P. O. A. D. P.
OF
LOCKHILL SELMA DEVELOPMENT

PRELIMINARY OVERALL AREA DEVELOPMENT PLAN APPLICATION (POADP)

Re: Lockhill Selma Development POADP # 524

The City Staff Development Review Committee has reviewed Lockhill Selma Development Subdivision Preliminary Overall Area Development Plan (POADP) # 524. Please find enclosed a signed copy for your files. You may now submit individual subdivision plat units at your convenience. Although your plan was accepted, please note the following:

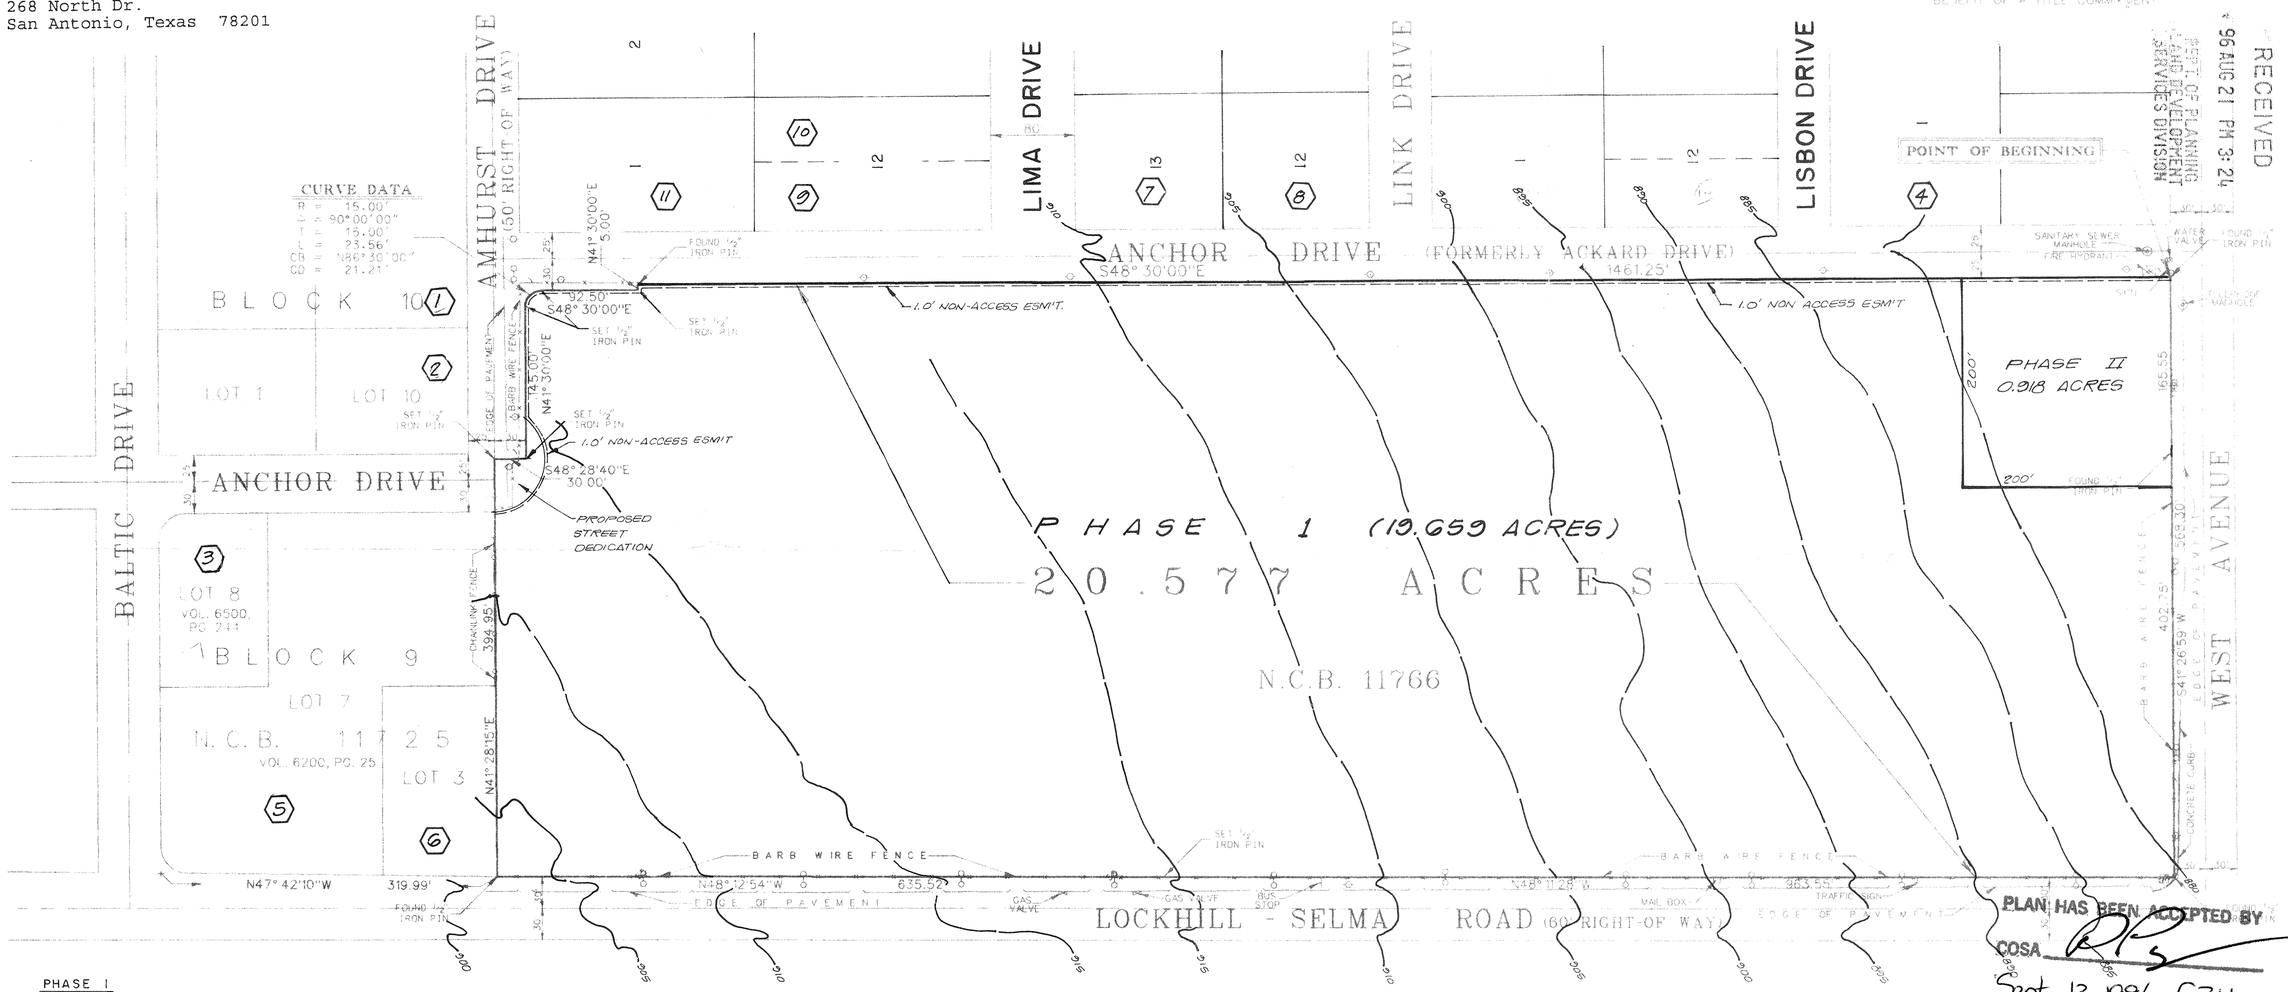
- Based on the topography, a Flood Plain Study and drainage review will probably be required during the platting process.
- West Ave. is a Secondary Type A Major Thoroughfare, and will require an additional 13' of ROW.

Comments: DRAINAGE EASEMENTS WILL BE REQUIRED AND DRAINAGE AREAS ADDRESS DURING THE PLATTING PROGESS with possible onsite or offsite drainage structures.
